Shop Drawing Submittal Review

Project Name: Webster University-**ISB**

Copies	No.	Description
1 PDF	224216P02	(Submittal No.'s)
		(Cannon #22 4216.16-001) - (Paric #15051-) – (WES #607)
		➢ **Commercial Sinks**
		• Clinical Service Sink CSS-1
		• Scrub Sink SS-1
		• Sink SK-1
		• Garbage Disposer GD-1
		• Sink SK-2
		• Sink SK-3
		• Mop Sink MS-1
		• Kitchen Sinks KS-1, KS-2, KS-3

PROJECT NAME:	Webster University ISB
LOCATION:	St. Louis Missouri
CLIENT PROJ. NO.:	N/A
WES PROJ. NO.:	607
SPEC SECTION:	22 4216.16 Commercial Sinks
SUBMITTAL ITEM:	See Below -

PFE1

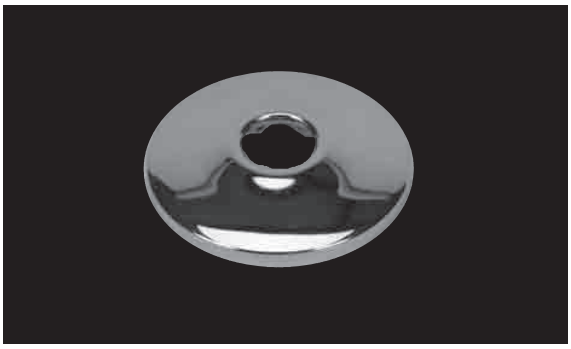
Escutcheons are specified to be cast brass. Refer to specification section 220518.
